MIL-M-28787/85A
AMENDMENT 1
28 April 1993

MODULES, STANDARD ELECTRONIC

MULTIPLEXER, DIGITAL, KEY CODE BDN

FIGURE 22. Power supply filter capacitance test circuit for table XX.

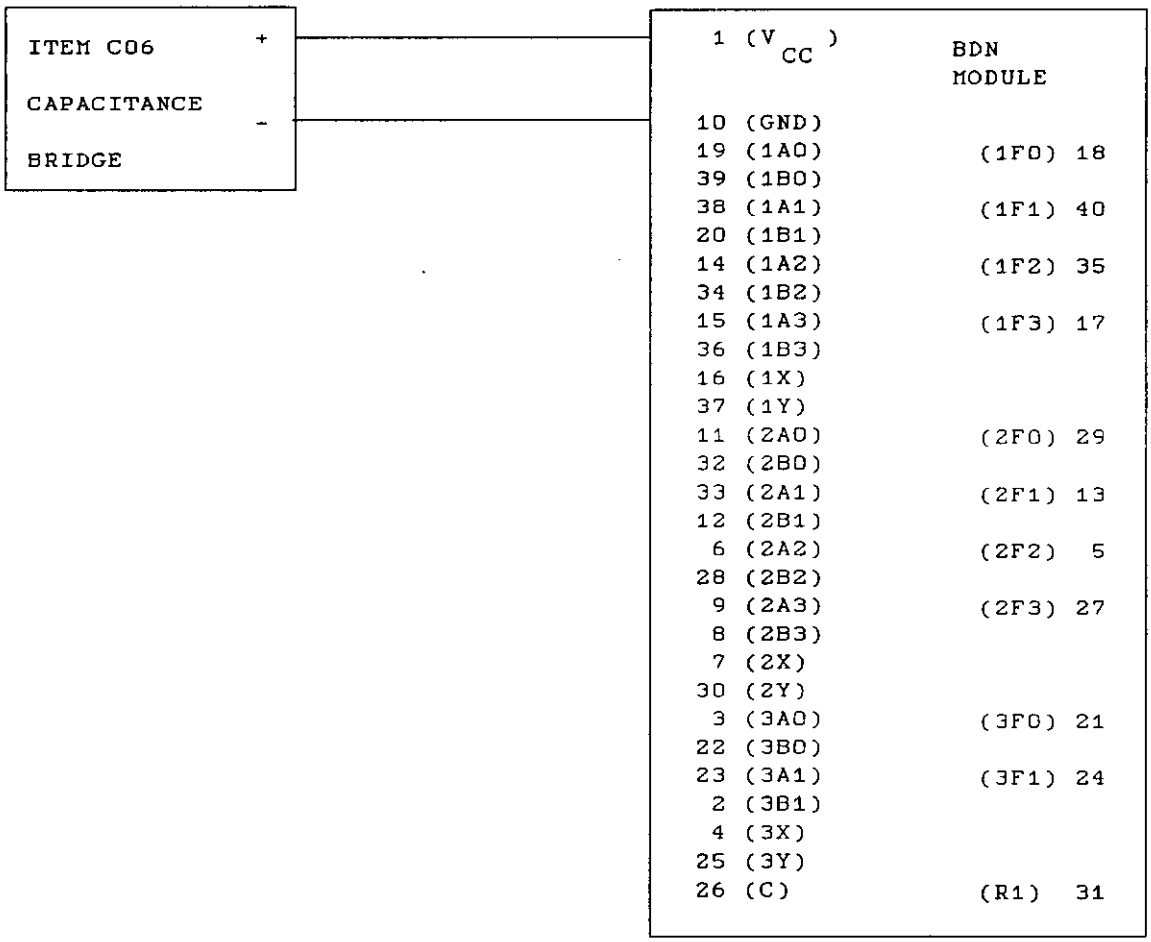
FIGURE 22: Delete and substitute new figure 22 as printed on page 3 of this amendment.

NOTE: Capacitance bridge C06 setup:
Frequency = 1KHz.
V_{pk} = 0.3V maximum.
